SM STAFF REPORT

| SUBJECT: | PRS 20-1306 | PLANNING AREA: | Riverview |
| REQUEST: | Minor Modification to an Approved PD | SECTOR | South |
| APPLICANT: | The Stellar Group, Andrew McDevitt | | |

Proposed Plan (PRS 20-1306)

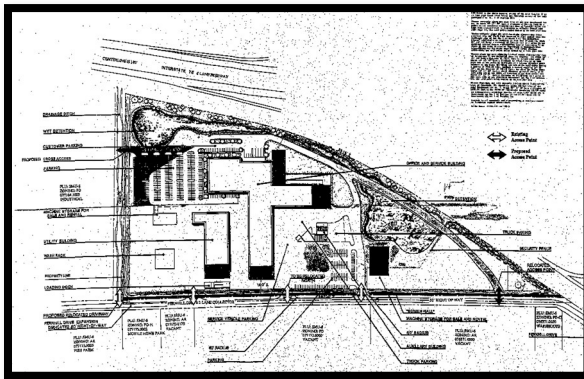
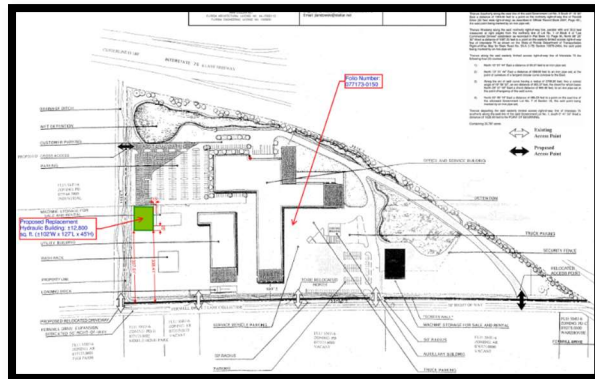
The applicant is requesting a minor modification to the approved Planned Development located on the west side of Fern Hill Drive, south of Gibsonton Drive. The applicant is requesting the following:

- To add an additional building footprint on the general site plan.

The applicant has submitted a revised General Site plan to reflect the requested changes.
